GULMOHAR RESIDENCY

Details of Additions & Alterations

Flat No	505	Block no.	'F'
Flat Area	1360 sft	Type	Deluxe / Luxury
Buyer Name	Ankush S Bhadda		
Phone No.	9550733375	Email

Description	Direction	Owners & Developers :	Date :	25.09.2020	Promoted by
	N	Modi Reality Mallapur LLP	Prepared By :	Jaypradha	Modi Properties Pvt Ltd
		Project Name & Phase :	Approved By :	Soham Modi	
		Gulmohar Residency	Scale :	N.T.S	Phone: +91-40-66335511
WORKING PLAN-1360 SR-AI TYPE

WORKING PLAN-1360 SF-A1 TYPE

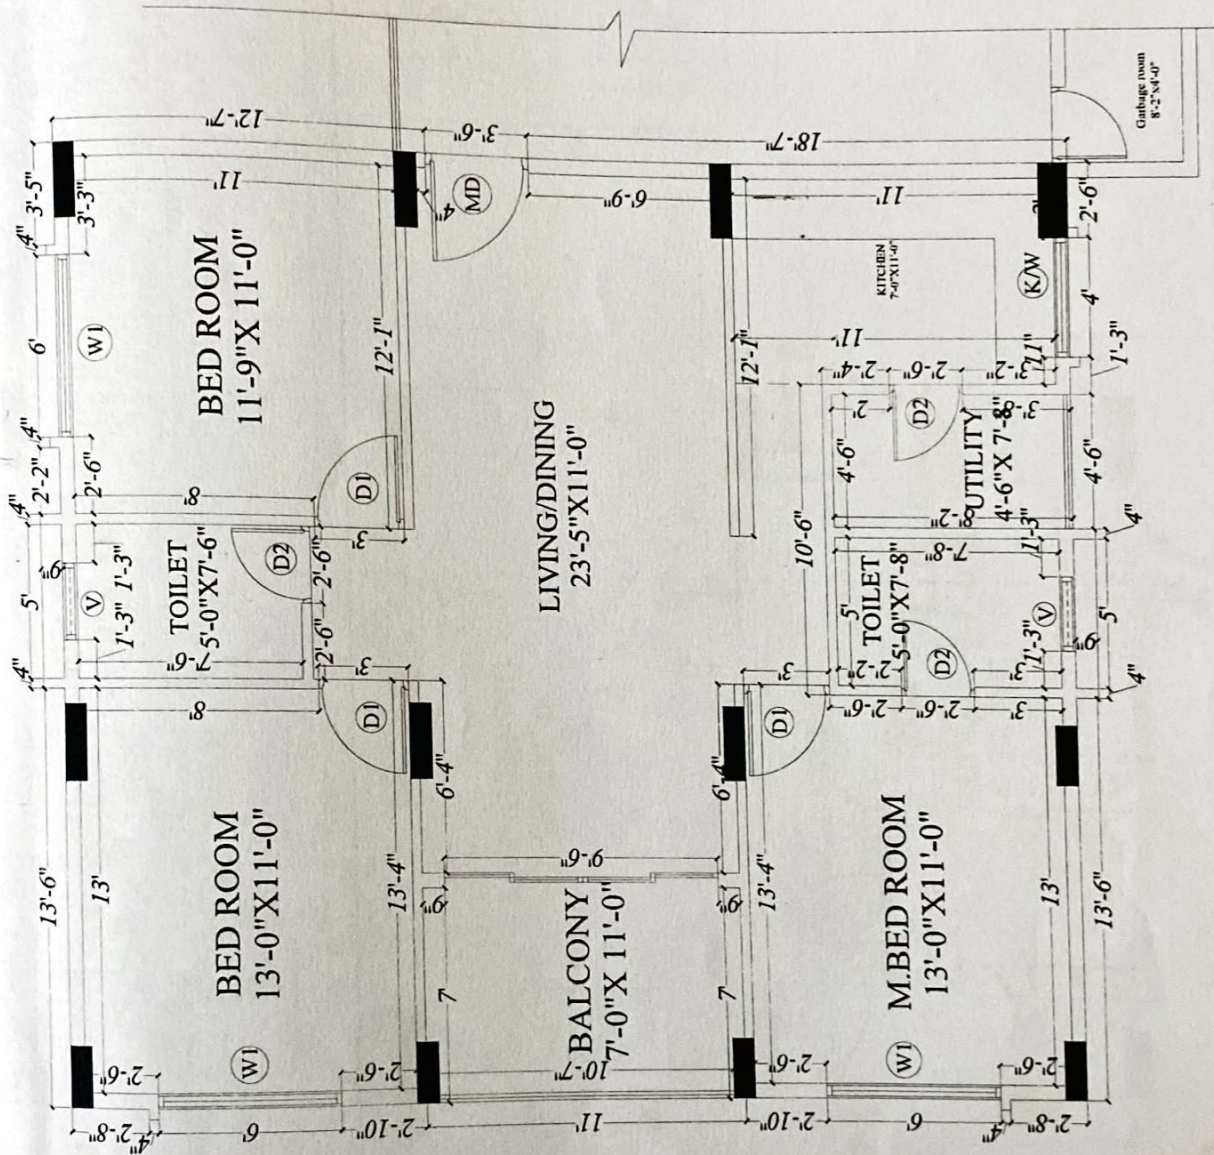
Changes in electrical points: (mark on plan)

Bathroom tiles:- CT: ultra sprinkle

MT: Malaysian Brown

flooring:- urban wood natural in 3 bedrooms

Hall & dining:- Not Selected (Carrel Beige) 2'x4'

Utility flooring:- wall Blanco white, flooring:- black berry.

Kitchen flooring:- Country almond

Balcony flooring:- Country mossow
